Access Compliance Report

Public Rights-of-Way

Intersection ID: 8816	Main Street: BROOKSTEAD MEADOW CT	Cross Street: NORKETT DR	Location: S
ADA ID: 692CB9F7C968	Ramp Type: PerpDiag	Initial Pass/Fail: Fail	Overall Compliance: No
Severity Score: 8.75			
Codes/Mitigation Info/Possible Solution		Field Measurements/Component Compliance

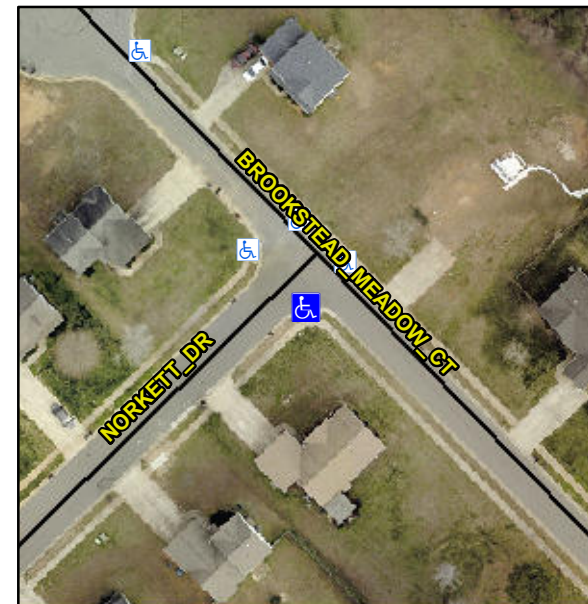
Not Found, R304.5.1

Compliance	Description	Data	Compliance	Description	Data
N/A	Ramp Length (in)	49.5	Yes	Ramp Slope (%)	7.8
No	Ramp Width (in)	41.0	Yes	Ramp XSlope (%)	1.2
N/A	Flare Type LT	N/A	N/A	Flare Type RT	N/A
N/A	Flare Slope LT (%)	N/A	N/A	Flare Slope RT (%)	N/A
N/A	Flare Traversable LT?	N/A	N/A	Flare Traversable RT?	N/A
N/A	Landing Length (in)	N/A	N/A	DWS Provided?	N/A
N/A	Landing Width (in)	N/A	N/A	DWS Contrast?	N/A
N/A	Landing Slope (%)	N/A	N/A	DWS Length (in)	N/A
N/A	Landing X Slope (%)	N/A	N/A	DWS Full Width?	N/A
N/A	Landing Curb? (Y/N)	N/A	N/A	DWS Offset (in)	N/A
N/A	Shared Landing?	N/A			
N/A	Gutter Ponding?	N/A	N/A	Gutter Slope (%)	N/A
N/A	Gutter Lip Ht (in)	N/A	N/A	Gutter X Slope (%)	N/A
N/A	Painted X Walk1?	No	N/A	Painted X Walk2?	No
	X Walk 1 Direction	To NE		X Walk 2 Direction	To NW
N/A	X Walk 1 Width (in)	N/A	N/A	X Walk 2 Width (in)	N/A
	X Walk 1 Slope (%)	1.0		X Walk 2 Slope (%)	1.7
	X Walk 1 X Slope (%)	0.0		X Walk 2 X Slope (%)	0.5

Remove & Replace Curb Ramp With Two New Directional Ramps or Equivalent.
